U_Power_Section
Power_Section.SchDoc
IO_4
IO_4
U_Battery Charging_Section
Battery Charging_Section.SchDoc
B_ADC
CHG
B_ADC
CHG
U_Audio_Section
Audio_Section.SchDoc
#12-P
#13-P
#14-P
#15-P
#12-P
#13-P
#14-P
#15-P
#O_MIC
#O_MIC
U_Controller_Section
Controller_Section.SchDoc
#12-P
#13-P
#14-P
#15-P
RX
TX
RTS
DTR
IO_4
#12-P
#13-P
#14-P
#15-P
RX
TX
RTS
DTR
IO_4
B_ADC
CHG
#O_MIC
SOFT_P
SDA_
SCL_
B_ADC
CHG
#O_MIC
SOFT_P
SDA_
SCL_
U_Sensor_Section
Sensor_Section.SchDoc
SDA_
SCL_
SDA_
SCL_
U_Connector_Section
Connector_Section.SchDoc
RX
TX
RTS
DTR
RX
TX
RTS
DTR
AC2
AC1
AC2
AC1
U_SMPS_Section
SMPS_Section.SchDoc
AC1
AC2
AC1
AC2

Power Section

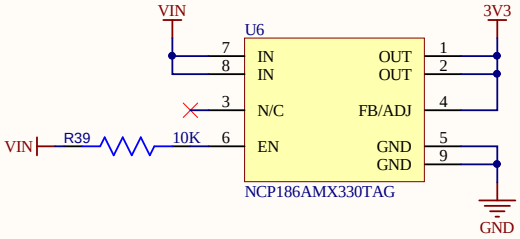
Place Decoupling Capacitor with there respective pins.

Battery Charging Section

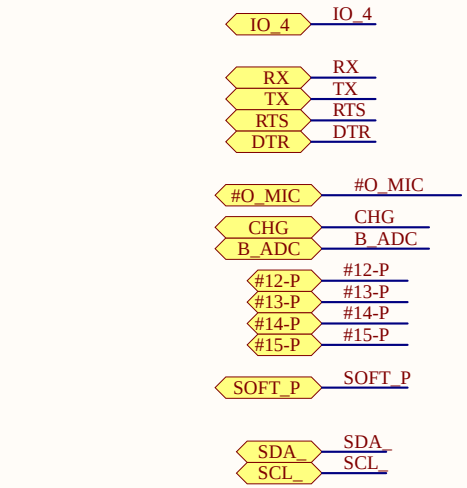
ISET Resistor Value is changed in Parameters, please be careful.

As per Datasheet, the value should not exceed 675 Ohm.

External Enable wouldn't be used as Development board already had circuit.

Controller Section

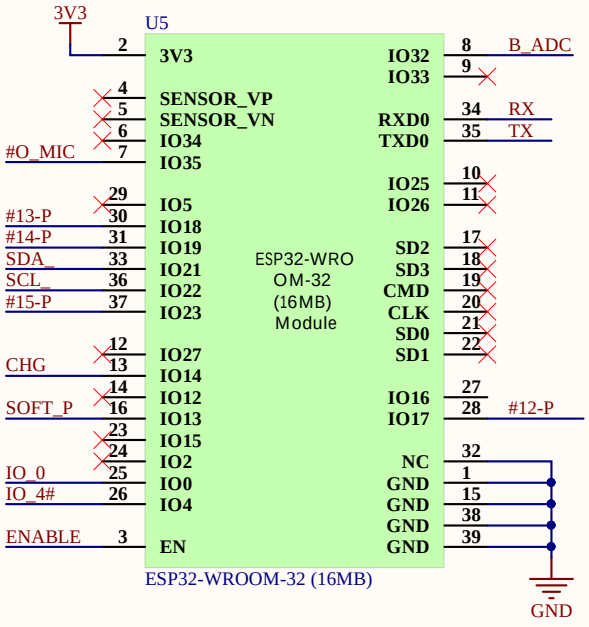
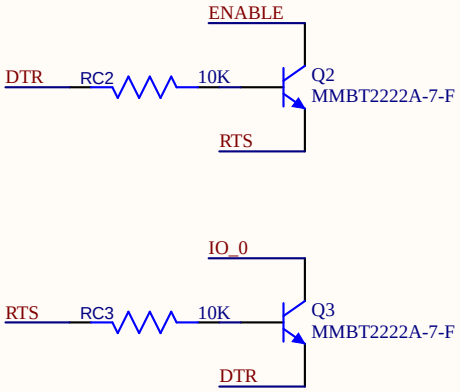
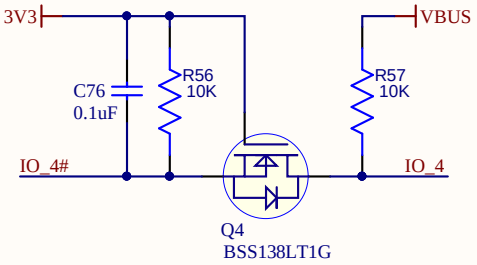
SW2 is being used for Software Reset.

Connector Section

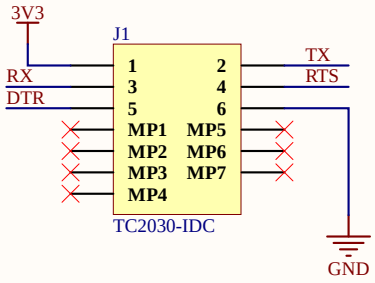
Mentioned Capacitors will be placed with Battery Connector and with USB Main Connector.

No Need to place Decoupling Capacitors with Switch as this is just path.
